ARCHITECTURAL ACCESS BOARD - HEARING PACKET

Name **New England Sports Center**
Address **121 Donald Lynch Blvd.**
City **Marlborough, MA 01752**

Site Visit Report

RE: New England Sports Center, 121 Donald Lynch Blvd, Marlborough (C24-002)

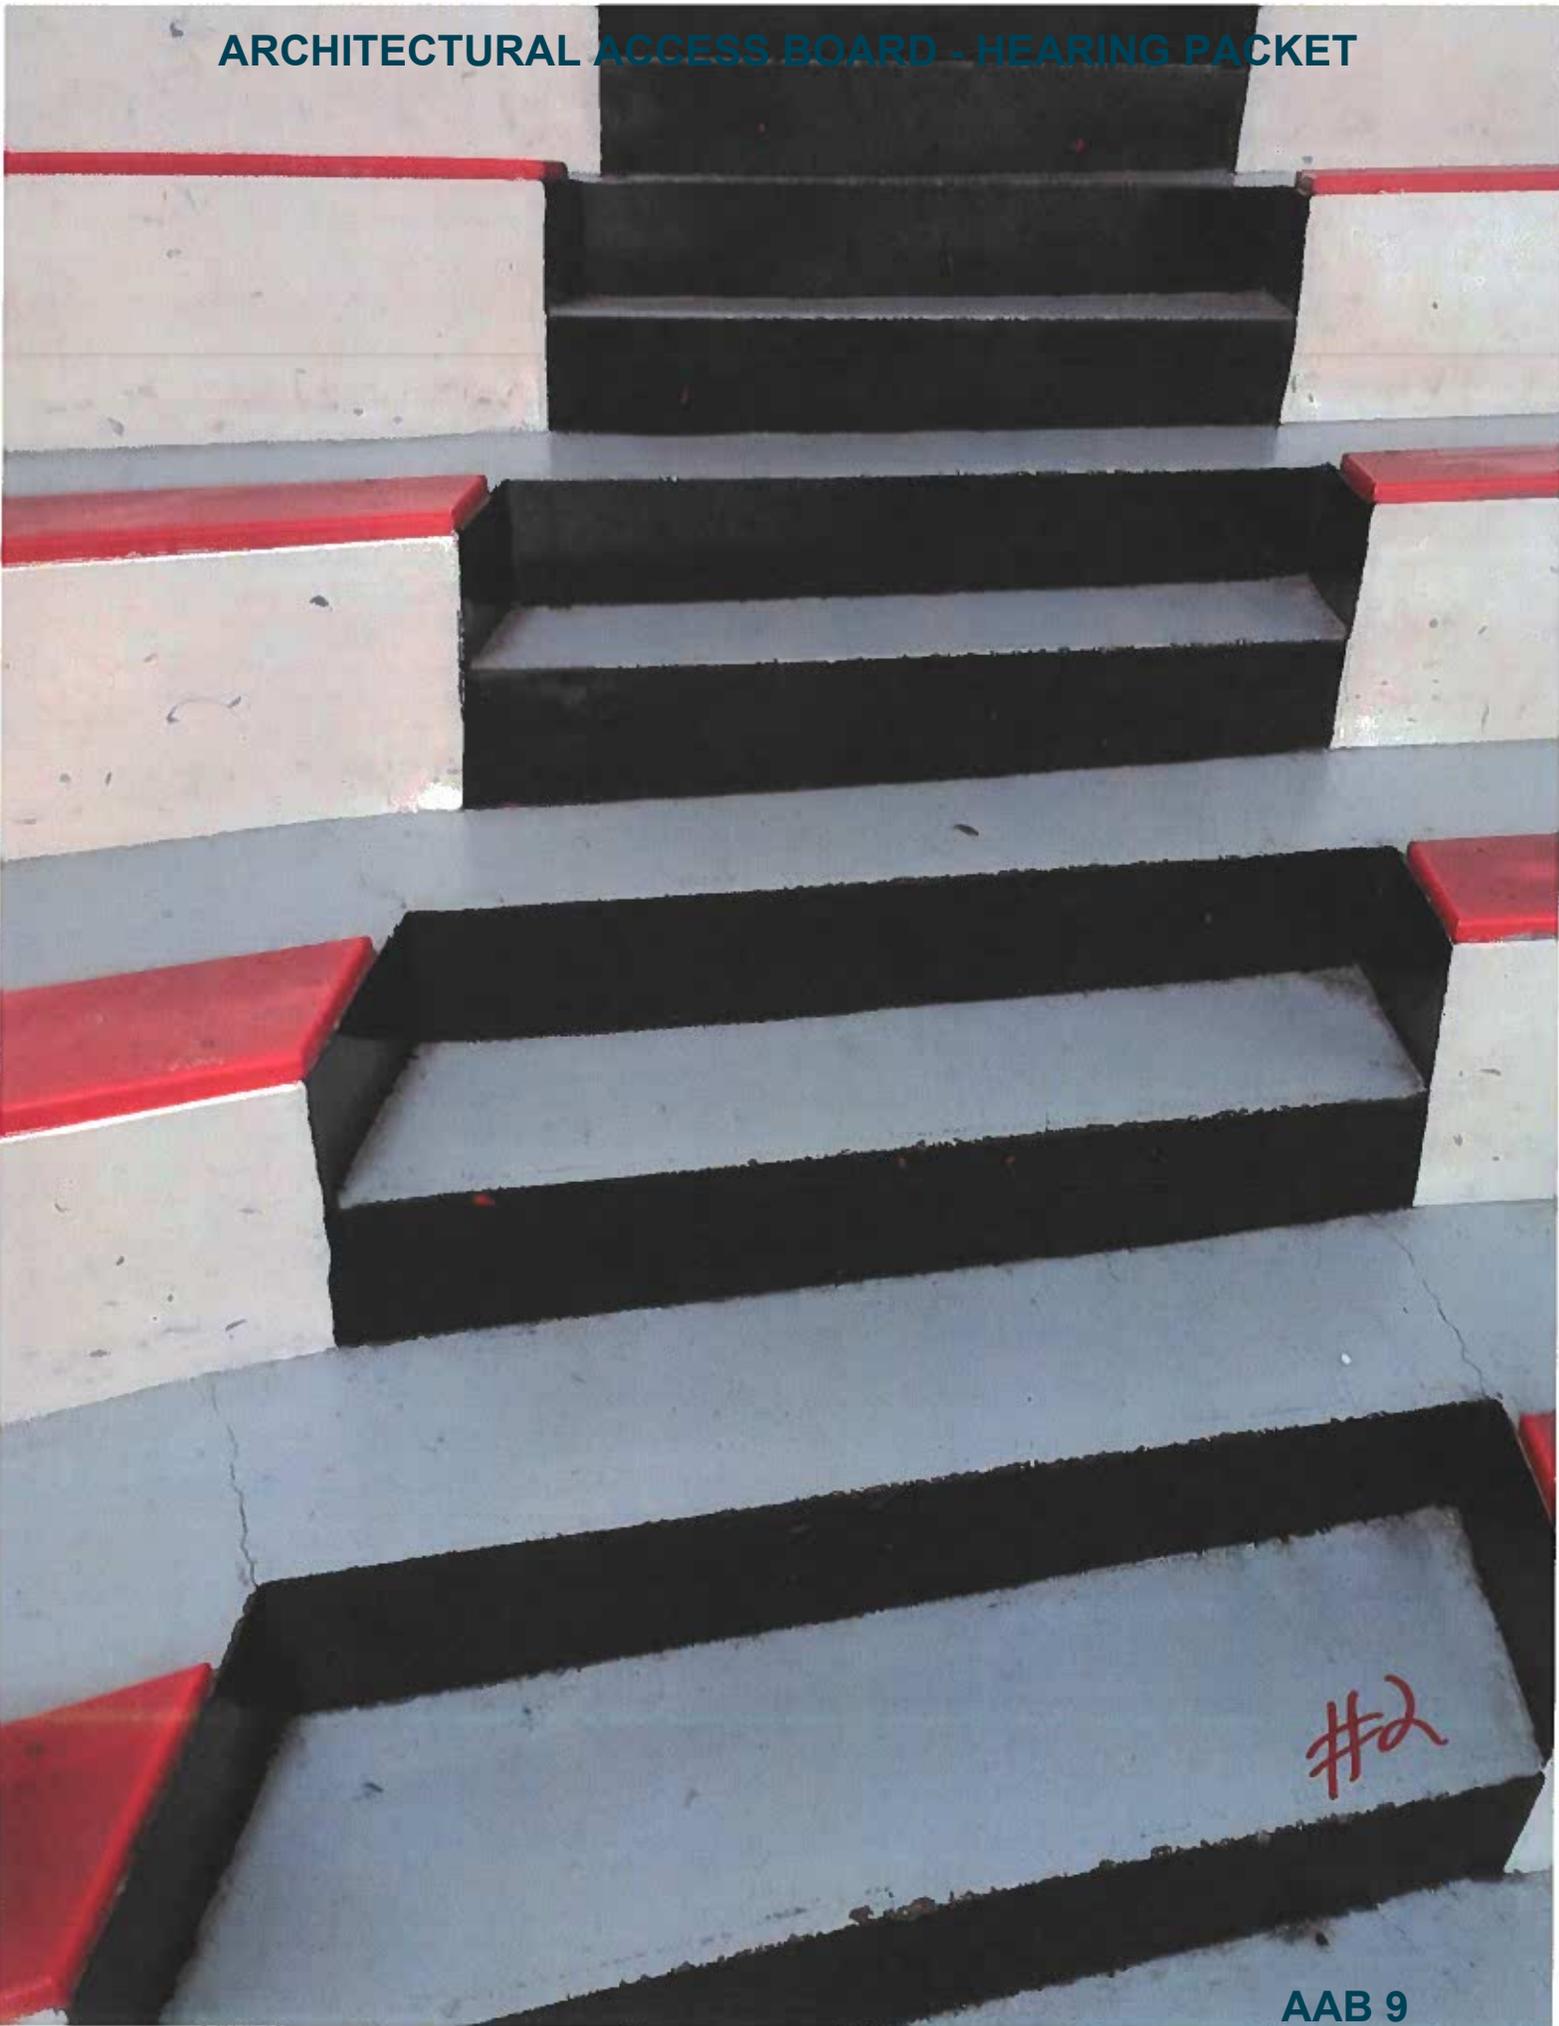
This Site Visit began in the facility's interior lobby where it was noted that the winding double-staircase located immediately adjacent to the entrance had been approved for a variance (V24-114) related to uniform treads and risers. It was also noted that the areas beneath the tread and riser system had already been blocked out to eliminate potential headroom violations per 521 CMR 20.7 (see photo #1).

Rink 1 was then inspected. Upon entering Rink 1, it was noted that stairs leading up to spectator seating area from 1st floor had uniform treads and risers, and compliant handrails. Stairs throughout spectator seating areas were noted as having uniform treads and risers but were missing handrails (see photo #2). It was also noted that Rink 1 lacked required number of accessible seats per 521 CMR 14.2. Additional stair in Rink 1 noted for lacking required 12-inch extension (see photo #3).

#4

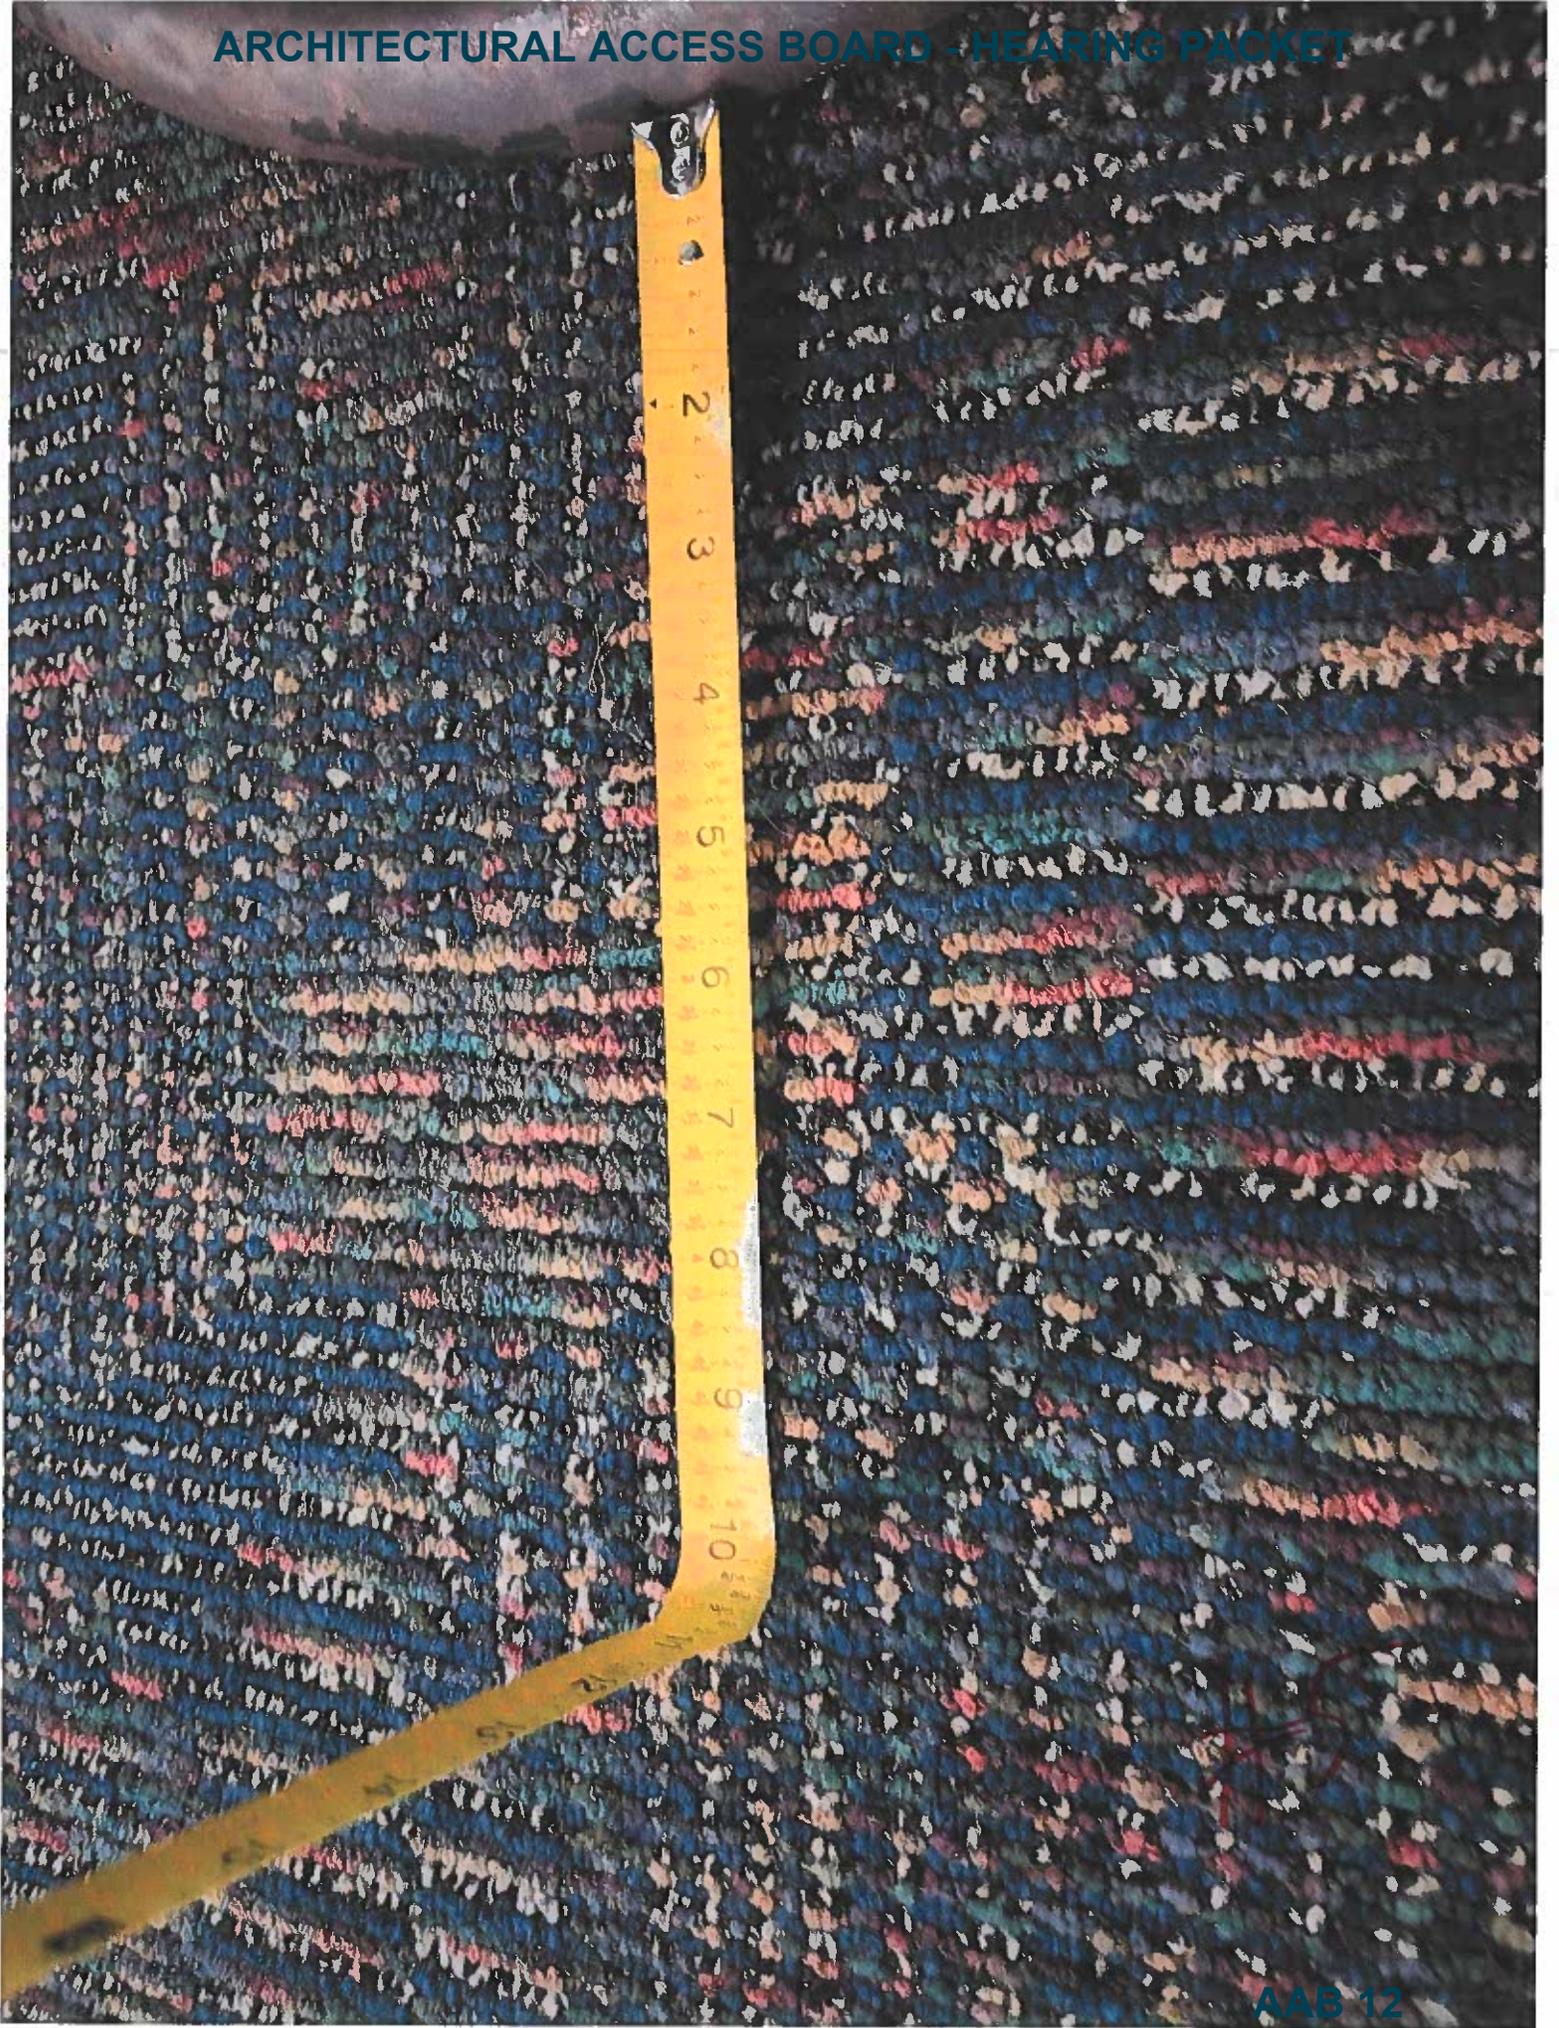
The stairs leading from Rink 1 to the second floor were noted as having compliant treads and risers, nosings, and handrails. As per 521 CMR 26.8.1, interior doors may have a maximum opening force of 5lbs. The door from Rink 1 into the second floor was measured at precisely 5 lbs. Additionally, a single designated accessible seating area was noted on the exterior of Rink 1 (see **photo #4**).

#6

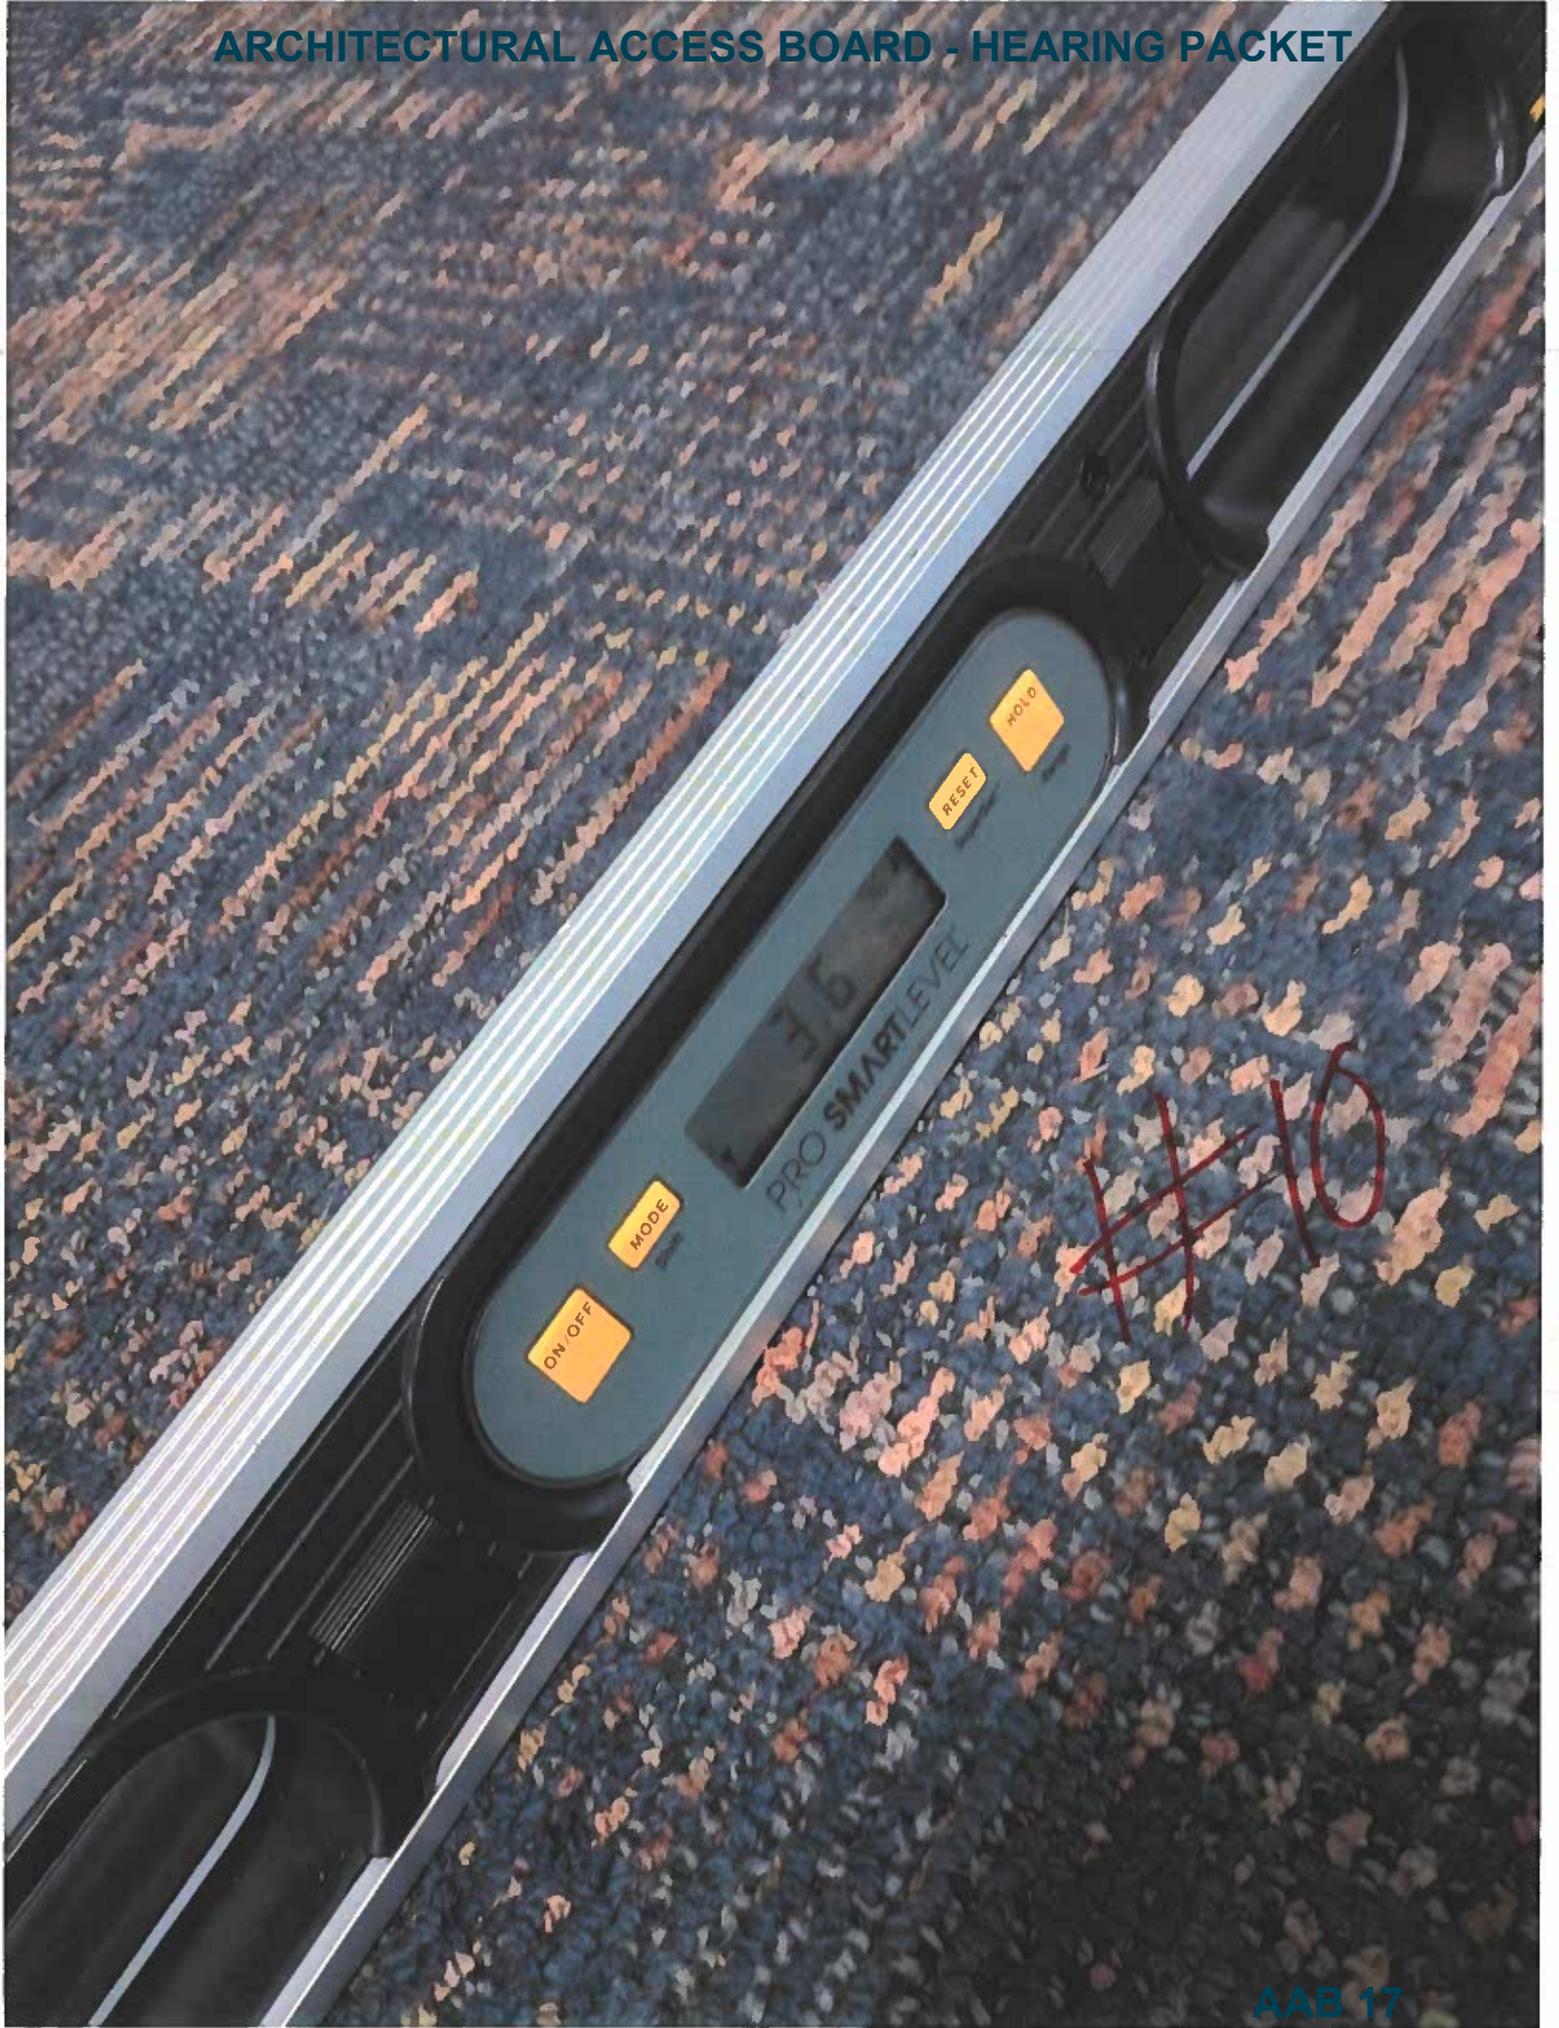
Three sets of common main stairs from the first floor to second floor were noted. All had compliant treads and risers. Non-compliant handrails were noted at all three locations, with stair one and three not having required extensions, whereas stair two had interrupted handrails (see **photo #6 and photo #7**).
